C600—As Fig. 1.  
C601 } As Fig. 1 except R12 is 68000 ohms and C23 is 0.01 mfd.  
C602 }

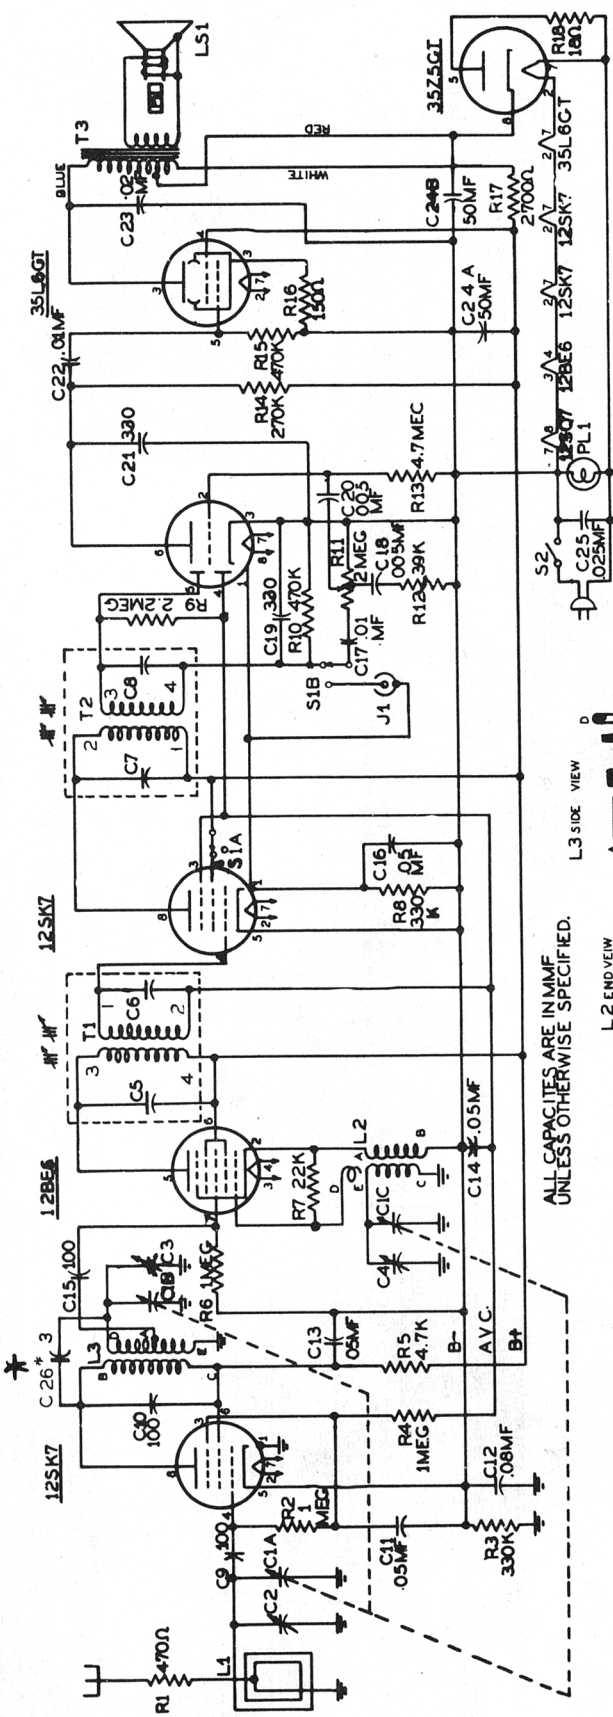
\*Note: C26 (3 mmf. ceramic) was used in some series, due to variations in L3. It was added to give a uniform gain across the band and to prevent a condition of loss of sensitivity at the high end of the band. If it is added where not required, it may be found that C3 will not have a low enough minimum capacity to peak secondary of L3.

The cathode of the 35L6GT tube should be pin 8 instead of pin 3 as shown.
